Service Bulletin

Bulletin No.: 20-NA-179

Subject: Malfunction Indicator Lamp (MIL) Illuminated – DTCs P0521 and/or P06DD Set

Brand:	Model:	Model Year:		VIN Breakpoint:		Engine:	Transmission:
		from	to	from	to		
Chevrolet	Corvette	2020	2020	SORP	September 10, 2020	6.2L (LT2)	—

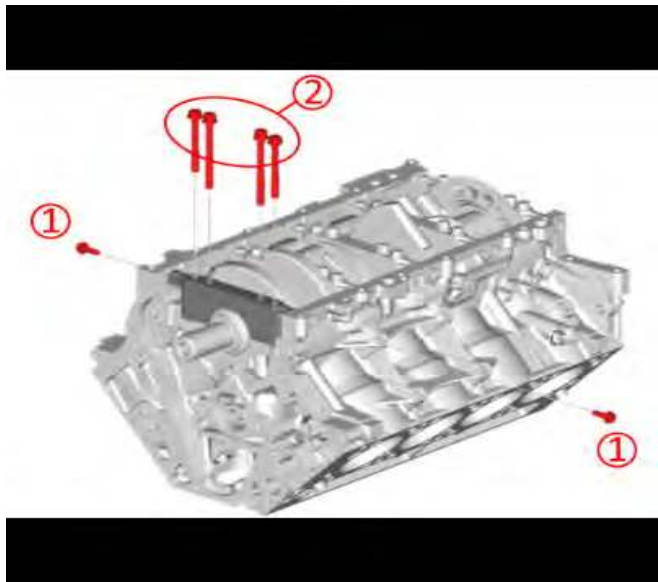
Involved Region or Country	North America
Condition	Some customers may comment that the MIL is illuminated. Some customers may also comment that the MIL will illuminate and then shut off. Some technicians may find one or more of the following DTCs set in the Engine Control Module (ECM): " P0521: Engine Oil Pressure Sensor Performance " P06DD: Engine Oil Pressure Control Valve Performance
Cause	This condition may be caused by an unseated engine oil pressure control valve (OCV).
Correction	The diagram shows two components. On the left, labeled with a red circled '1', is a redesigned oil pressure control valve retainer clip. On the right, labeled with a red circled '2', is the engine oil pressure control valve (OCV). Both components are shown in a cross-sectional view, highlighting their internal structure and the points of contact. Note: If a vehicle comes in with one of these DTCs, follow SI for both DTCs to ensure there is not an electrical fault or other hardware concern. After diagnosis has been performed and no issues are found electrically, then it will be necessary to remove the engine oil pan and inspect for a unseated engine oil pressure control valve, which is mounted on the bottom of the engine oil pump. If P0521 and P06DD DTCs are present, then a redesigned oil pressure control valve retainer clip (1) may be necessary. Refer to the Service Procedure section below.

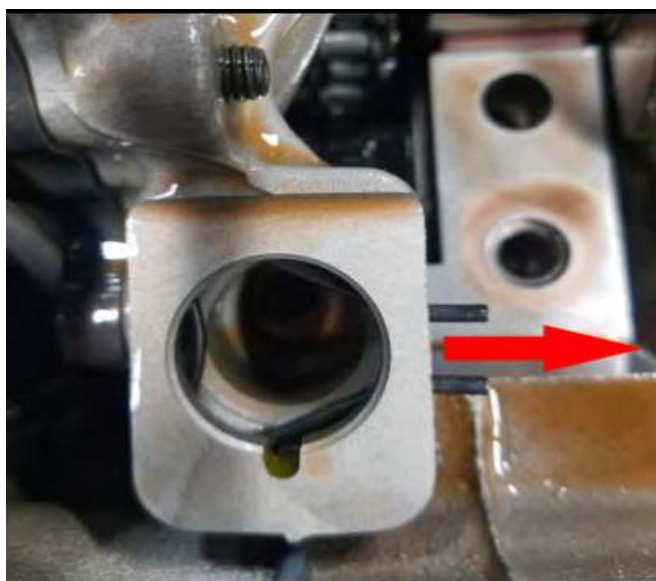
2. Remove the main cap side bolts (1).

Important: When removing the main bearing cap be careful not to damage the main bearing or journal surface of the crankshaft. Please set the main bearing cap in a safe place so no debris or damage could occur.

3. Remove and discard the bolts (2) that secure the #1 main bearing cap.
